DATE: 11-27-18

APPLIES TO: This service bulletin applies to 2017 through 2018 model year, MetroStar Emergency Response, chassis built between 5/16/2017 and 6/28/2018.

CONDITION: Exhaust harness missing support bracket and hardware, which may cause harness to rest on exhaust.

FIG 2.1

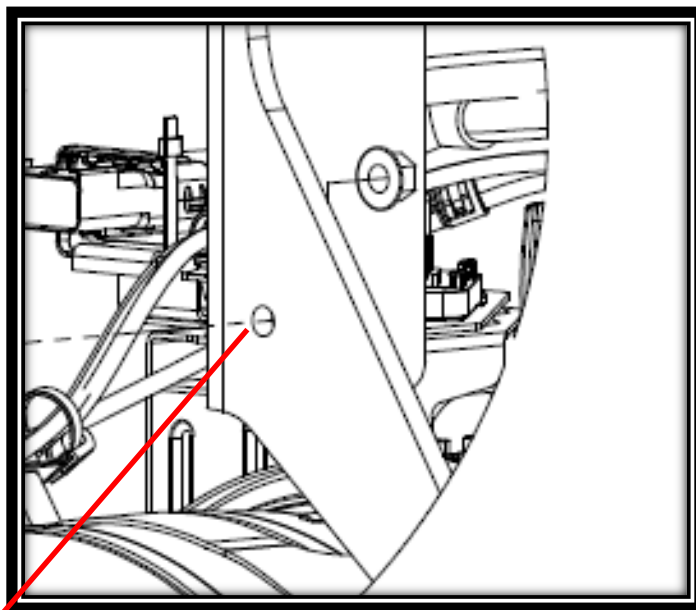
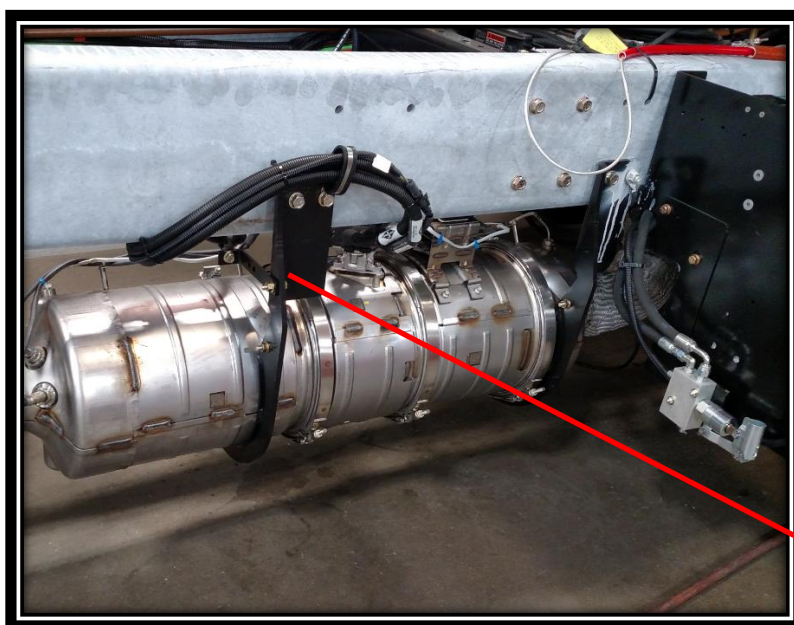
1. Locate hole in rear exhaust support bracket. Refer to FIG. 2.1 and FIG. 2.2.

FIG 3.1

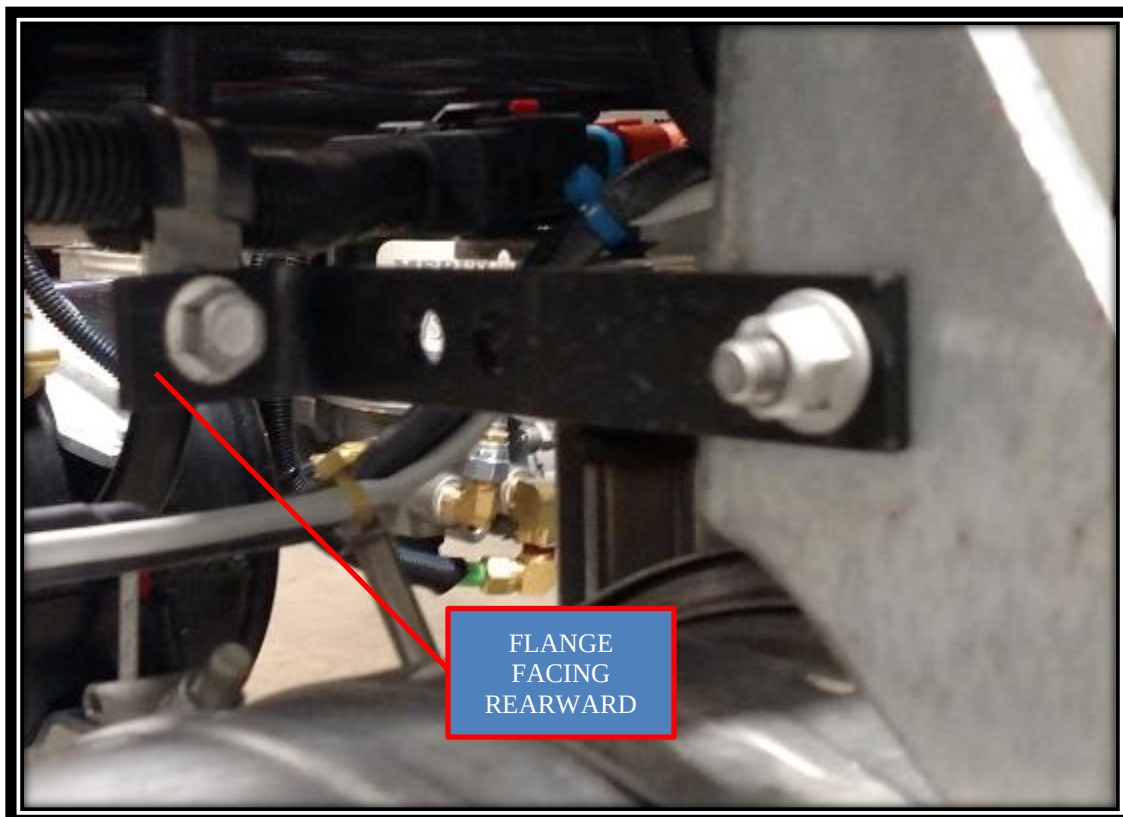
2. Using provided hardware, bolt standoff bracket to exhaust support bracket. Mounting bracket horizontal, with short flange of bracket facing rearward of vehicle, and torque 27-34 lbf-ft. Refer to FIG. 3.1.

FIG 4.1

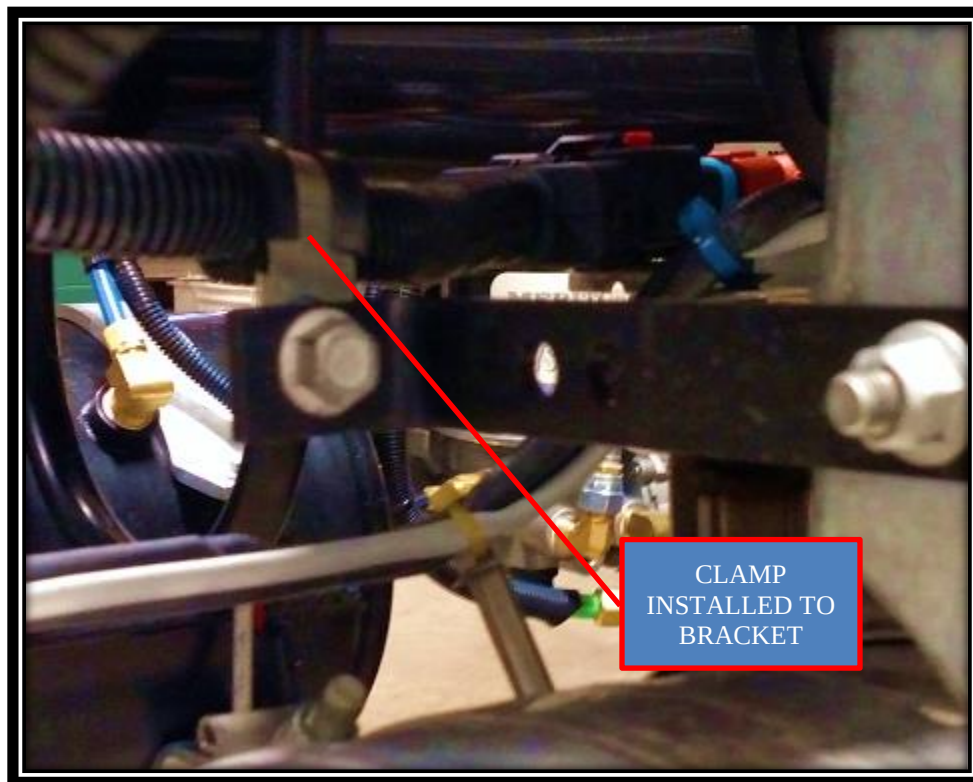
3. Install clamp around exhaust harness approximately 6" from connection to exhaust controls. Attach clamp to short side of flange with supplied hardware and torque 27-34 lbf·ft. Refer to FIG. 4.1.

FIG 5.1

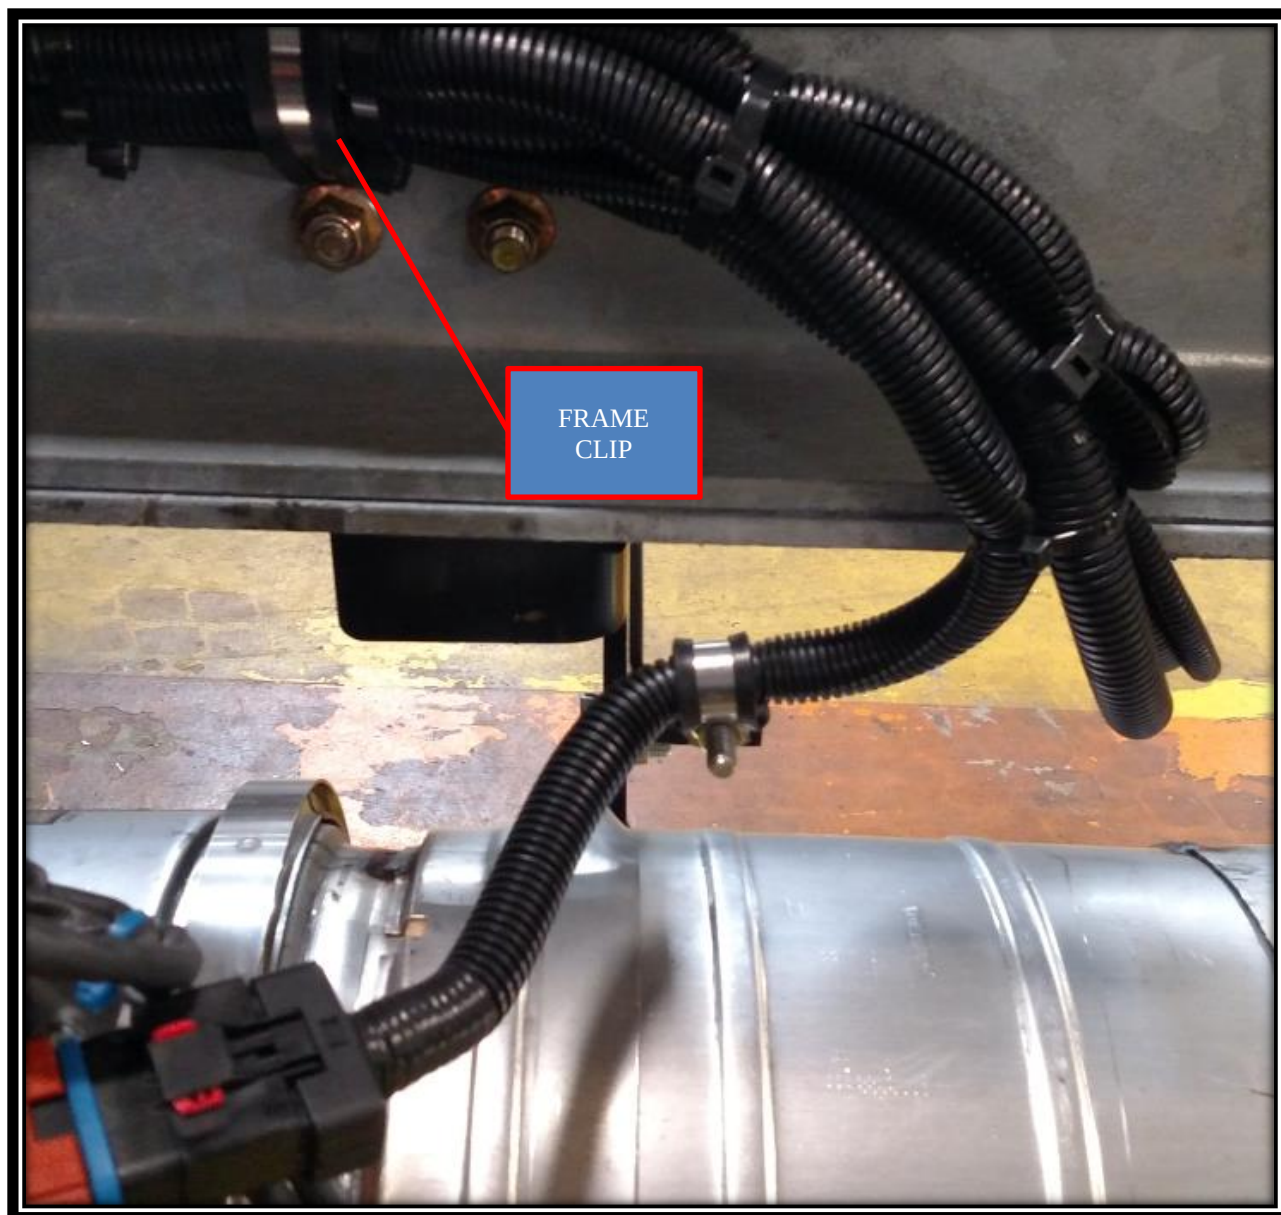
4. Route harness rearward below frame rail then loop upward into frame securing harness with frame clips. Refer to FIG. 5.1.
